From: [Dan Rublee](#)
To: [Thanh Dang](#); [Meghan T. Rupkey](#); [Adam Fletcher](#); [Laura A. Dent](#); valerie.washington@harrisonburgva.gov; heja.alsindi@harrisonburgva.gov; brent.finnigan@harrisonburgva.gov; richard.baugh@harrisonburgva.gov; kate.nardi@harrisonburgva.gov; shannon.porter@harrisonburgva.gov
Cc: lglascho@gmail.com; hlb20490@gmail.com; mvs@fplegal.com
Subject: Proposed R-1 to R-8 Rezoning on Smithland Rd - Riverbend Investments
Date: Tuesday, February 4, 2025 7:03:11 PM

From: Dan Rublee
Sent: Wednesday, October 18, 2023 5:37 PM
Subject: Smithland Rd Development Concept Plan

PETITION

Re: Proposed Rezoning of 10+/-ac from R-1 to R-8 along Smithland Rd

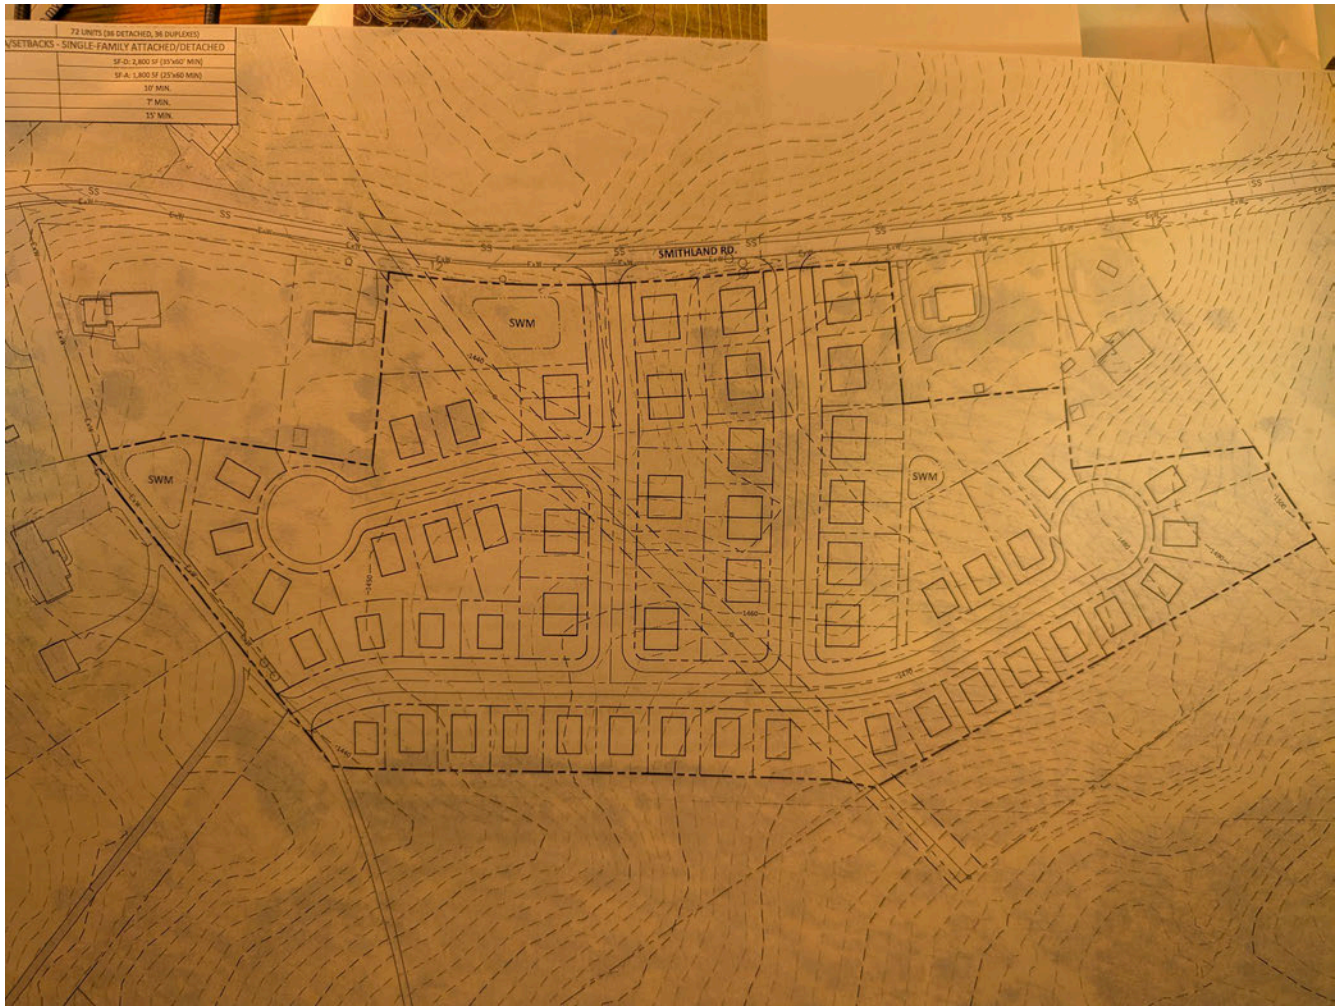
- The discharge from this site goes under Smithland Rd and flows through a cultivated field for a short distance, then through a residential yard, and then back into the field. This residential yard is already plagued by excess wetness making it difficult to maintain. We would like to see you work with one or both of these property owners to create a diversion around this backyard to reduce the added impact from your development on this situation. You can see below the current flow path in blue, and the desired diversion in red. I would think this could be arranged as a cooperative effort without the need for any formal easement.
